Briefing session questions for the following tender

TA135-RFP/TVO/2020/30-HENLEY NEWS BRANDING AND GRAPHICS

Questions & Answers

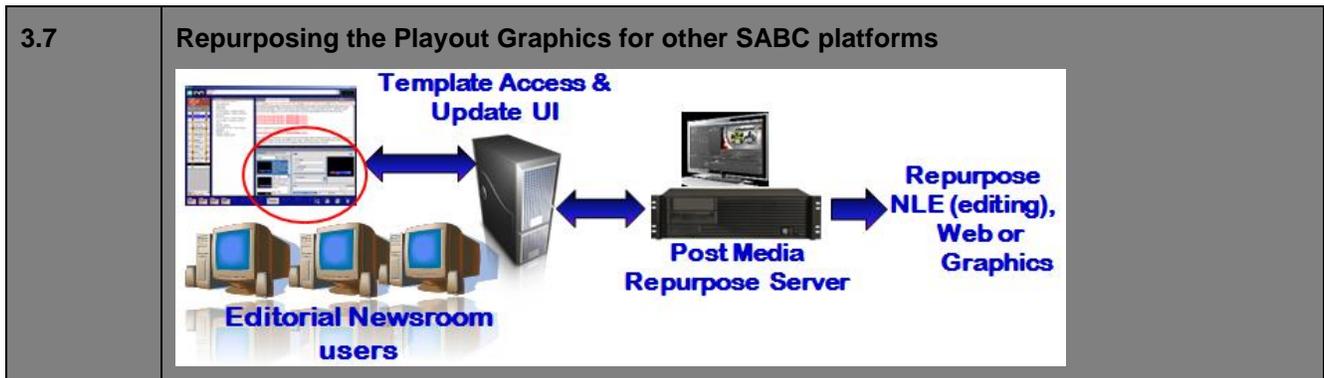
Question 22) 3.7.4

Added features for digital on-line publications

Could you give more details here or give an example, please?

Templates populated with picture/s, graphics, animations or rendered movie elements for Web page inserts or polled updates of full graphics or element animated graphics can be used as graphics to web pages or elements for keyed graphics for IP or YouTube streamed video; e.g. Lower third of presenter name that can be keyed in for a live video stream using WireCast or VMix applications.
